# Additional Concerns on CR4/CR10 Specifications

July 14, 2009

Ali Ghiasi, Vivek Telang, Magesh Valliappan  
Broadcom Corporation  
aghiasi@broadcom.com

# Reference 10 m QSFP Cable Loss

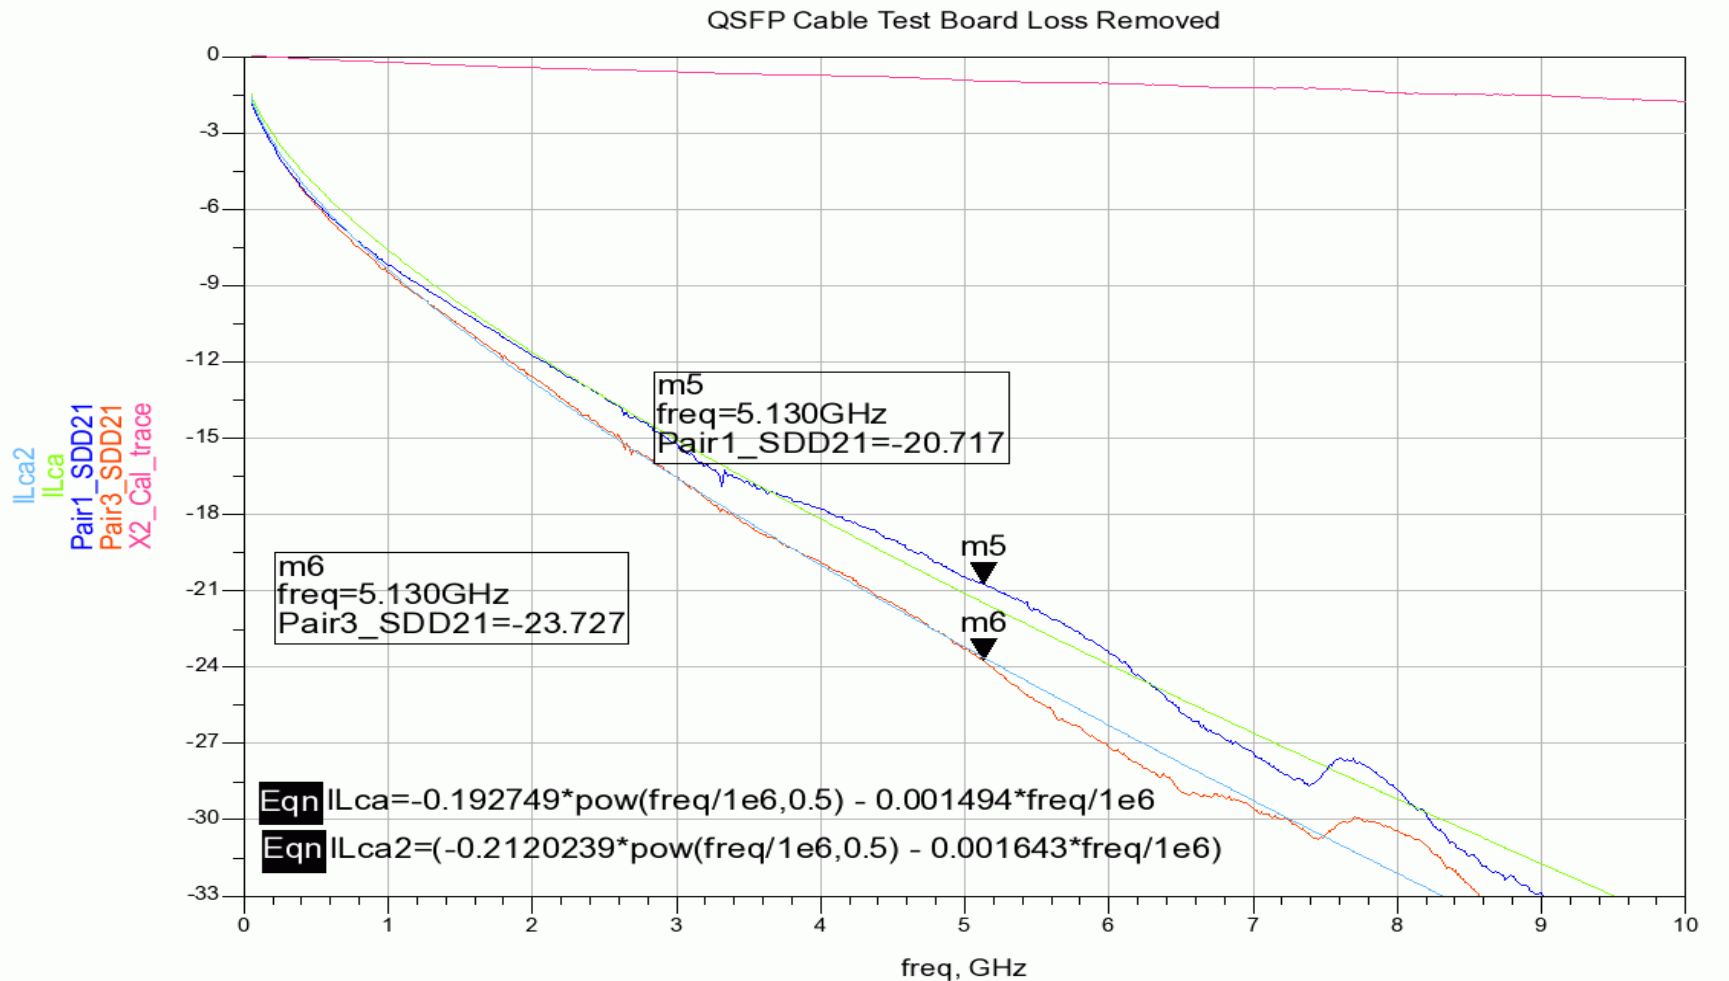
- Low loss pair matches Eq 85-50 exactly, but high loss pair has 3 dB more loss!

# Reference 10 m QSFP Cable Return Loss

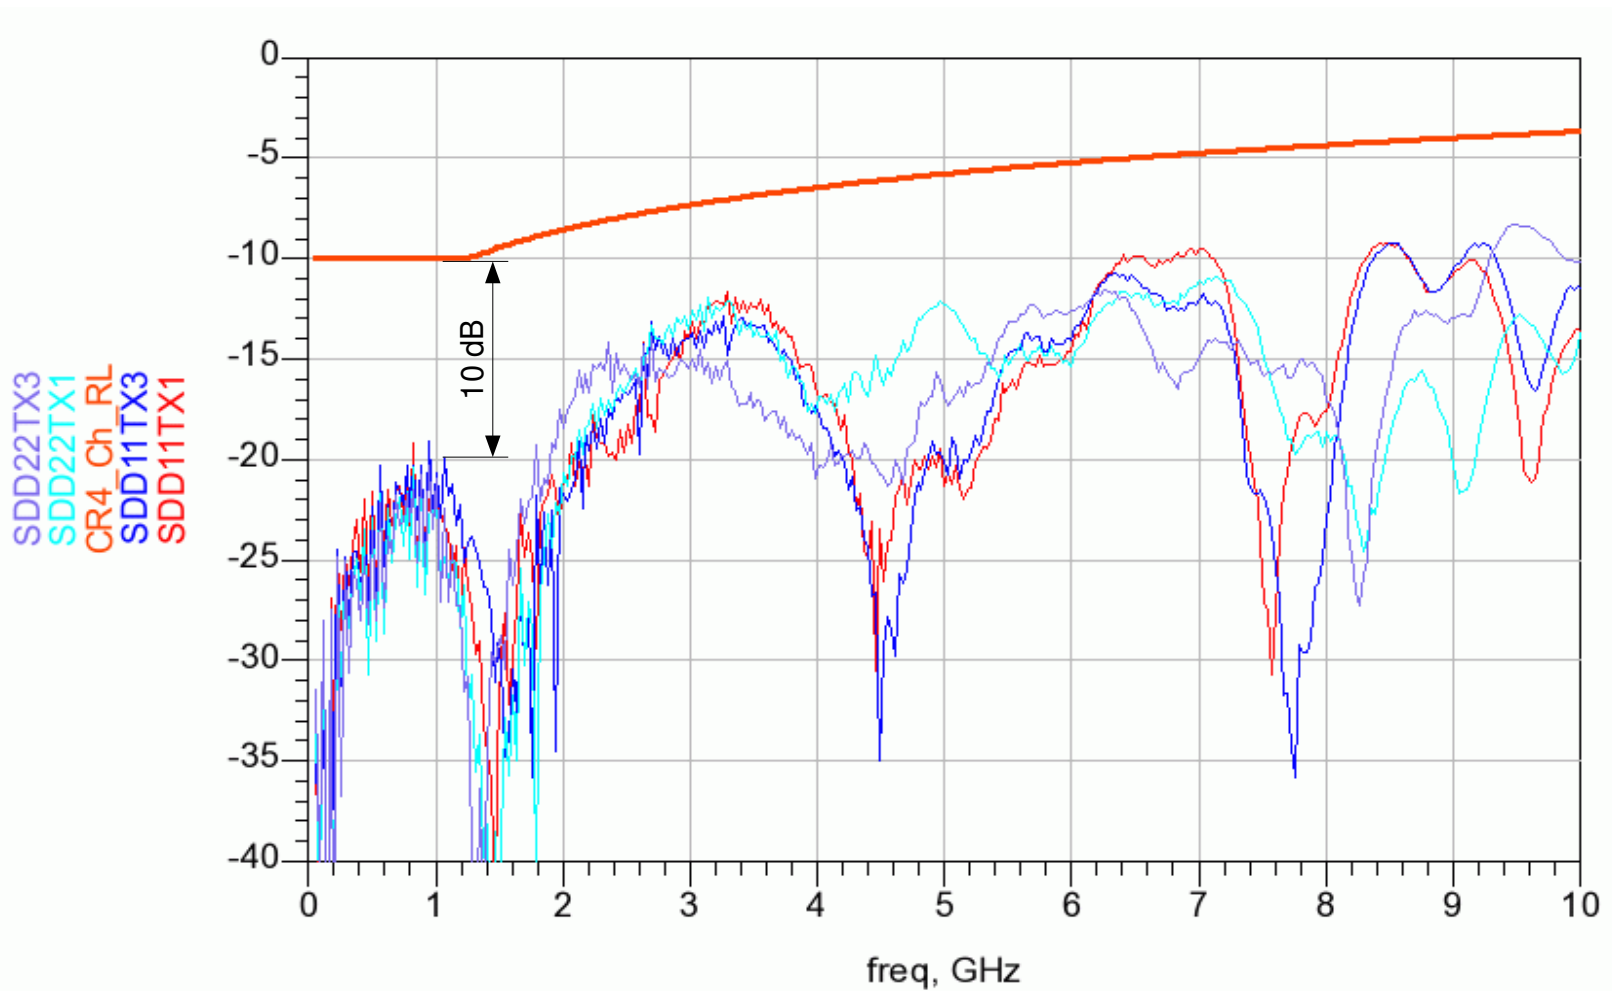
- Cable return specifications Eq 85-60 is 10 dB worse than reference cable!

# Where is the Source of Additional FEXT

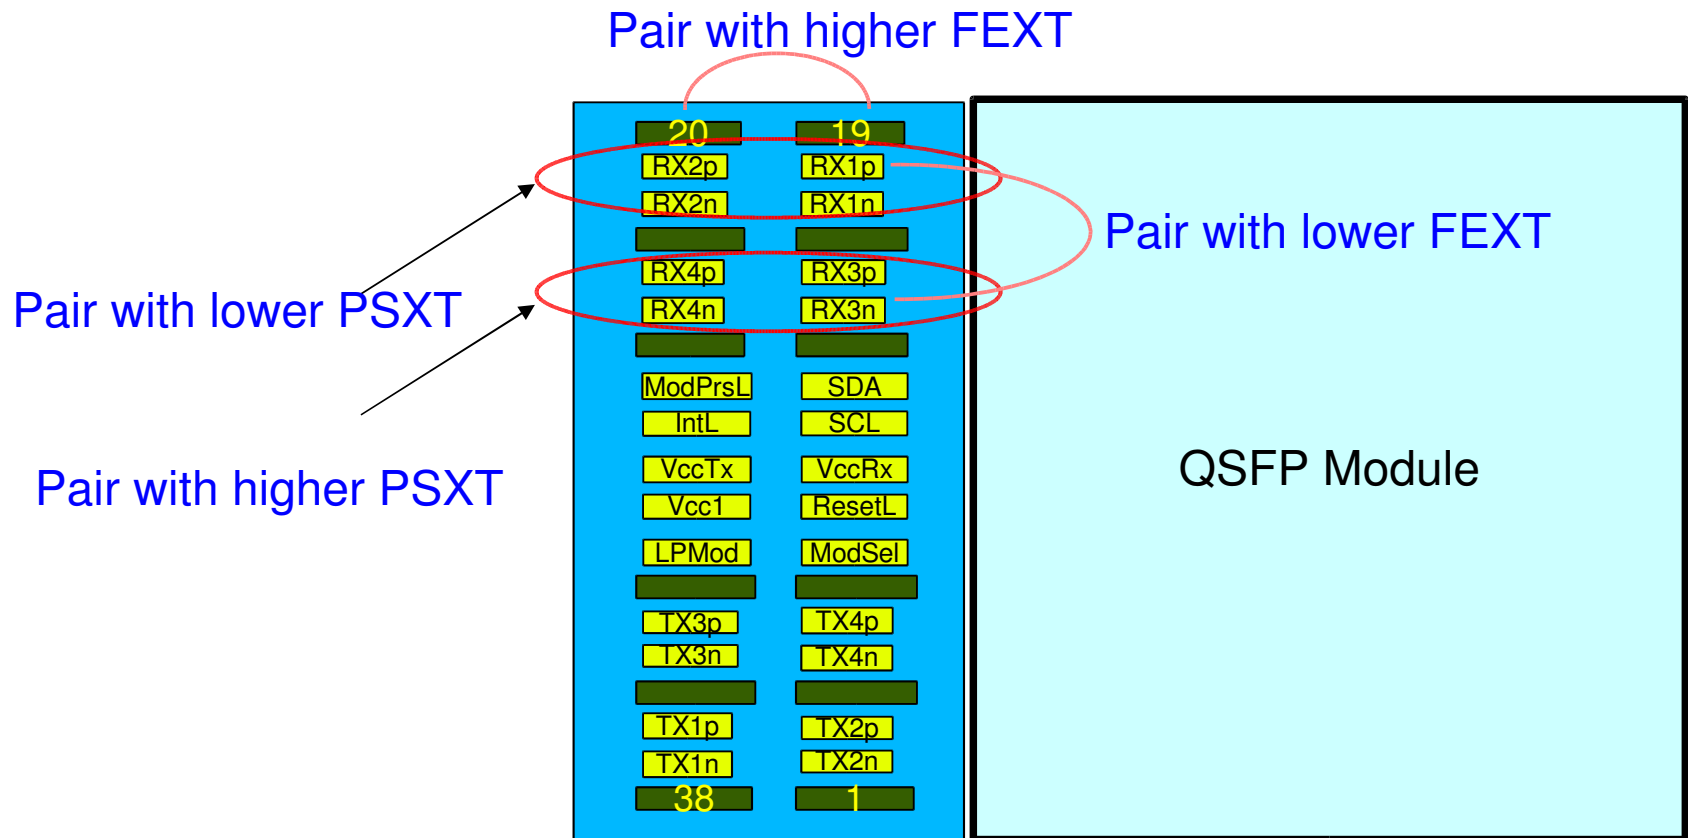
- It appears that worst case FEXT data (RX4 and RX3) were not included in daminico\_01\_0708

# FEXT and ILD on Low Loss Cable Pair

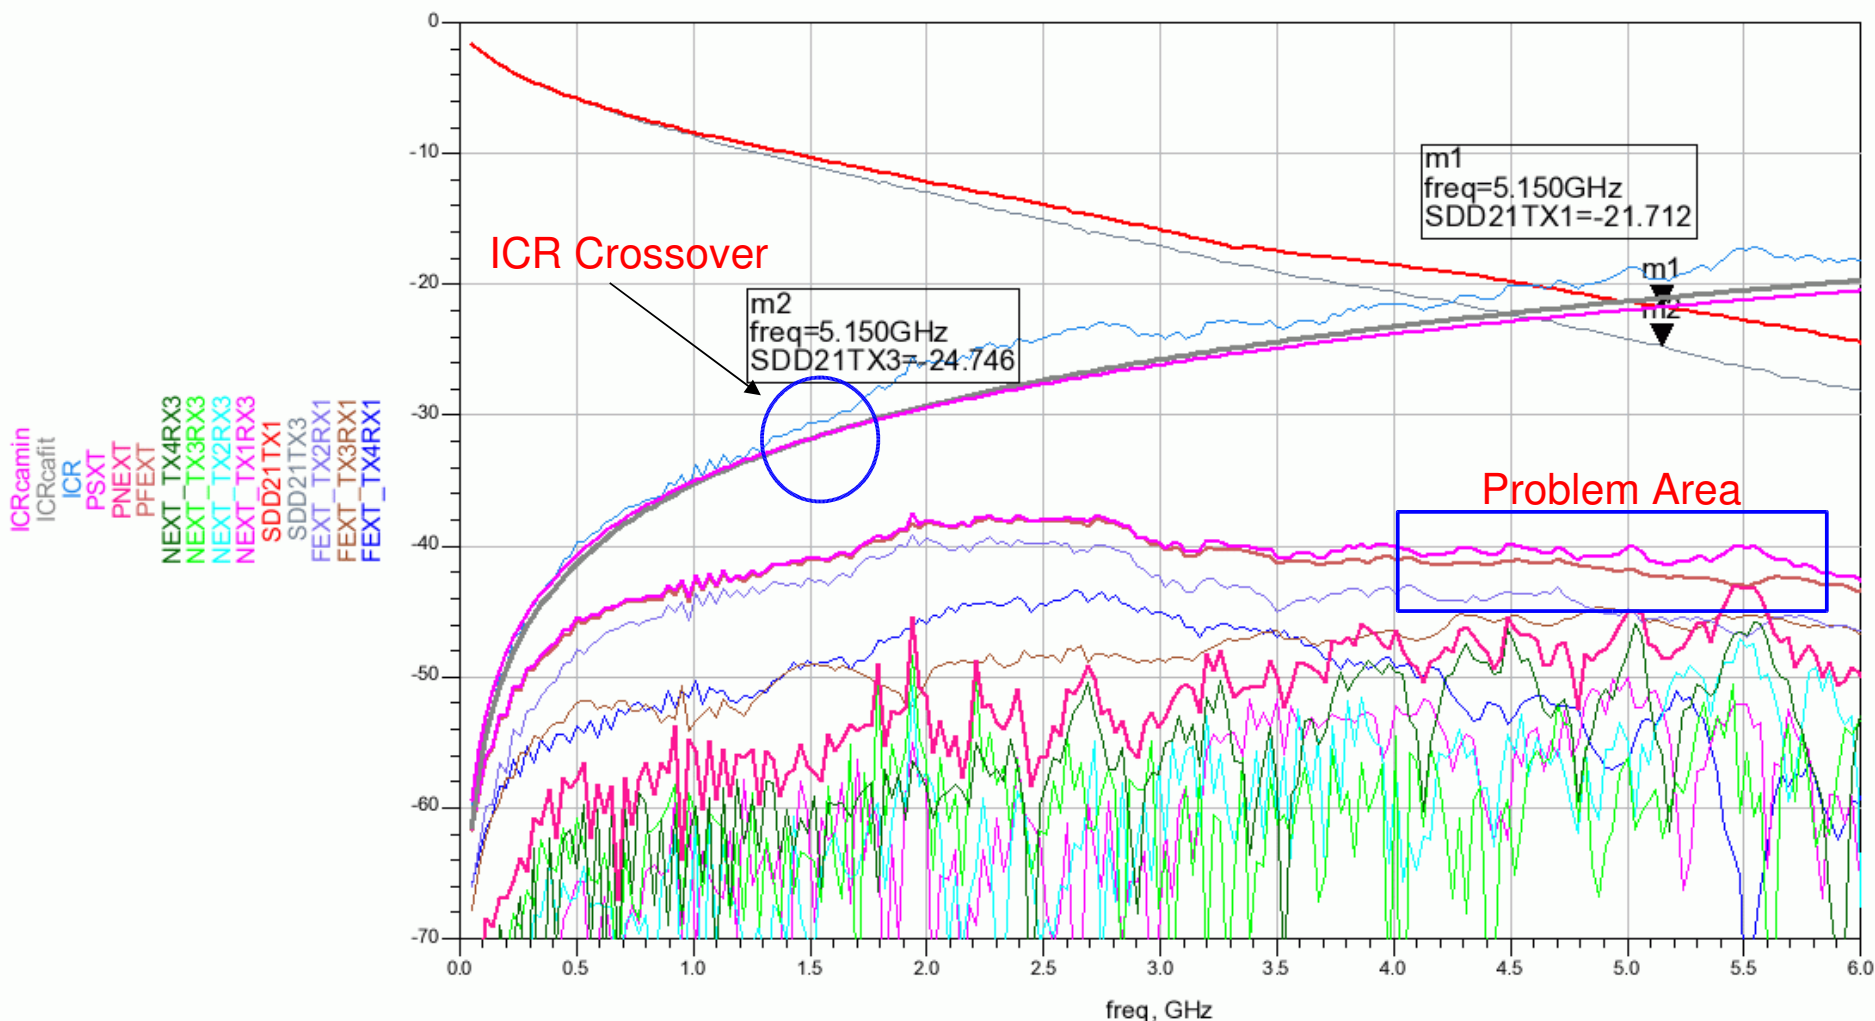
- Including 3 FEXT disturber on RX1

- Used 4 NEXT disturber on RX3 instead since RX1 is one signal pair further away

# FEXT and ILD on High Loss Cable Pair

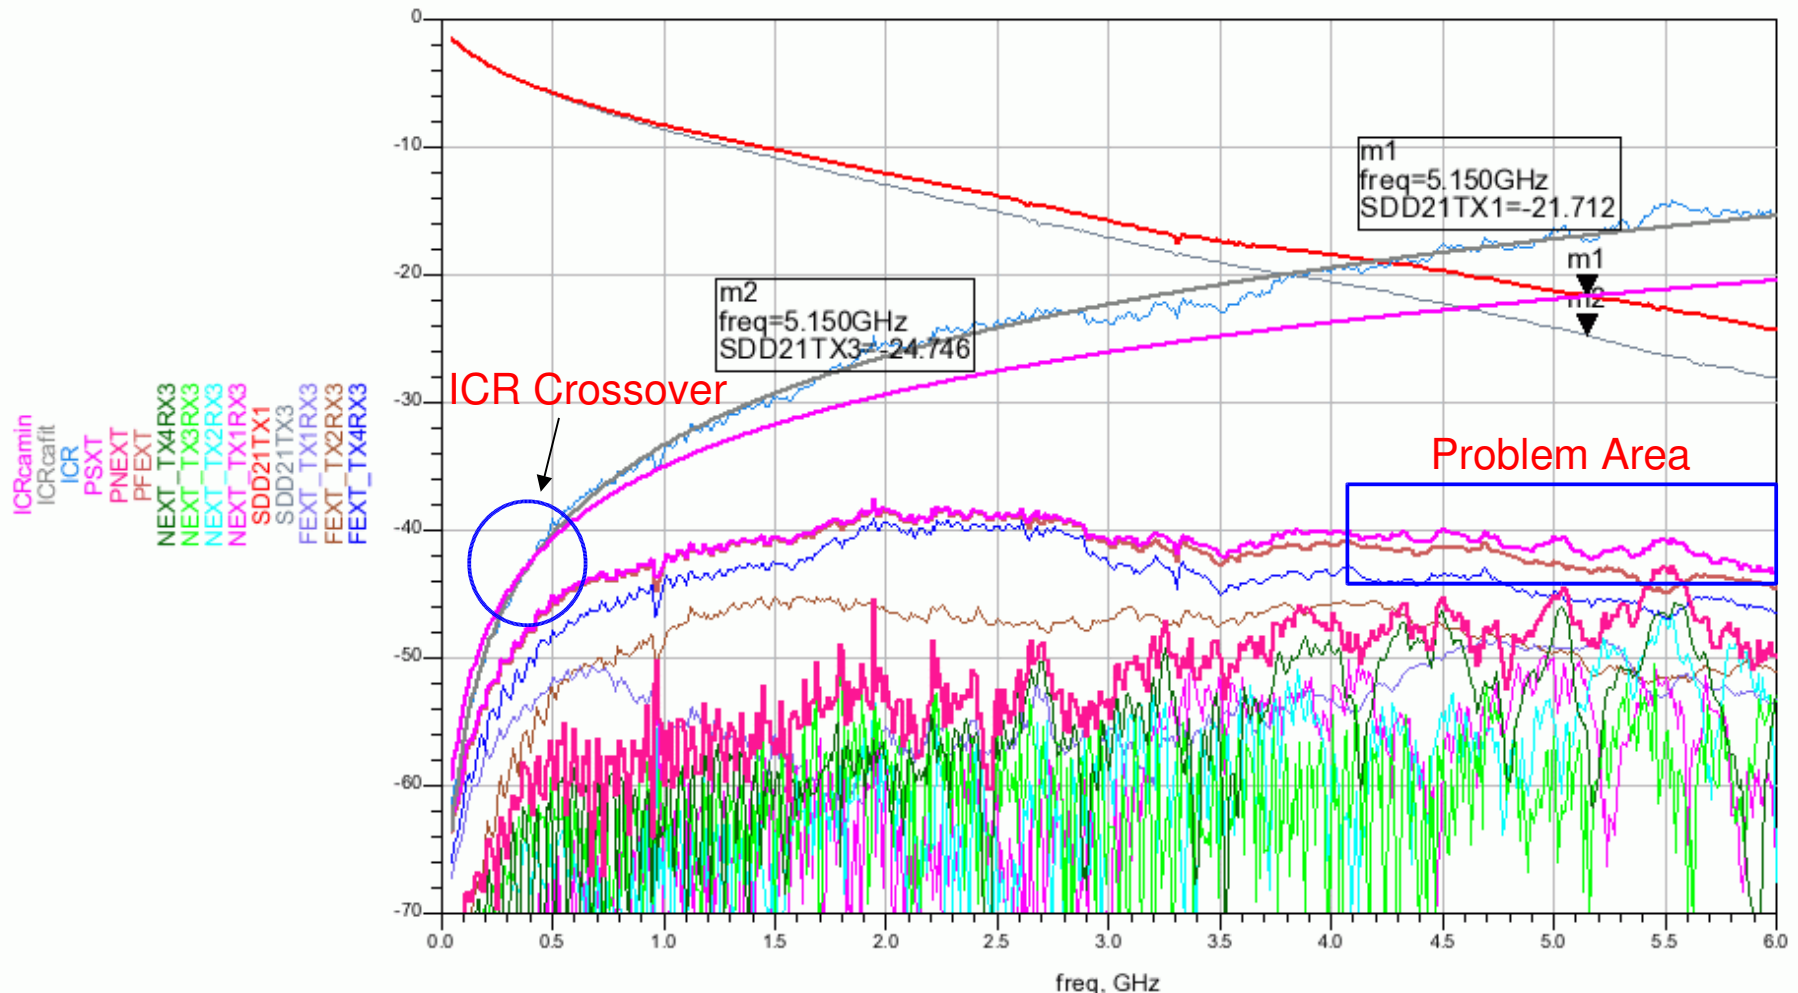
- Including 4 NEXT disturber and 3 FEXT disturber on RX3

# QSFP MCB-HCB FEXT-NEXT

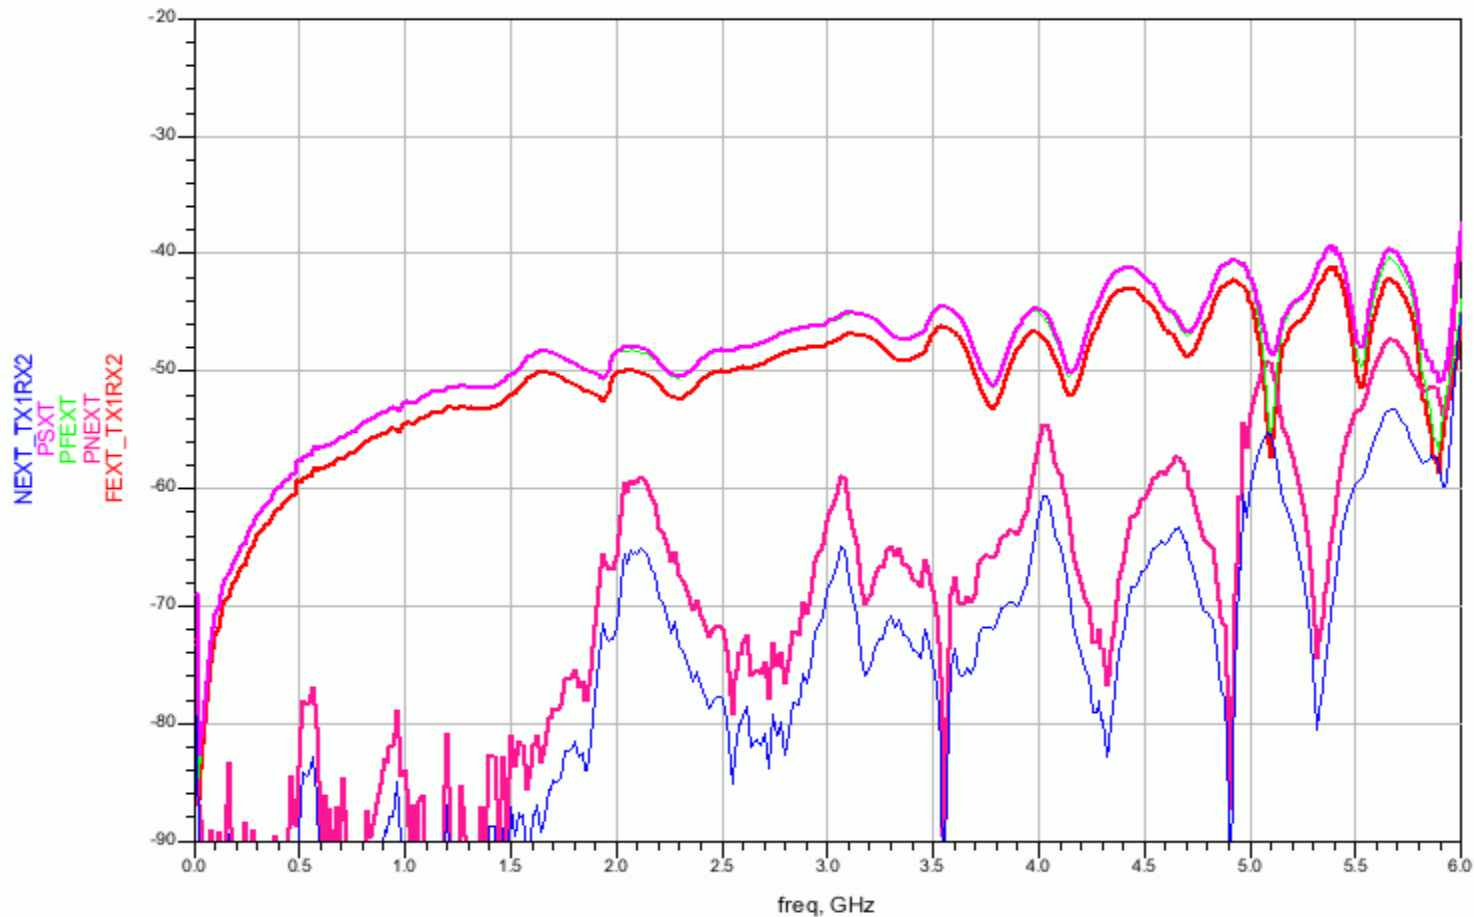
- PNEXT assumed to be 4x TX1RX2 NEXT
- PFEXT 2 dB higher than PFEXT for TX1RX2
- Connector is the dominant factor to PSXT ~5 GHz
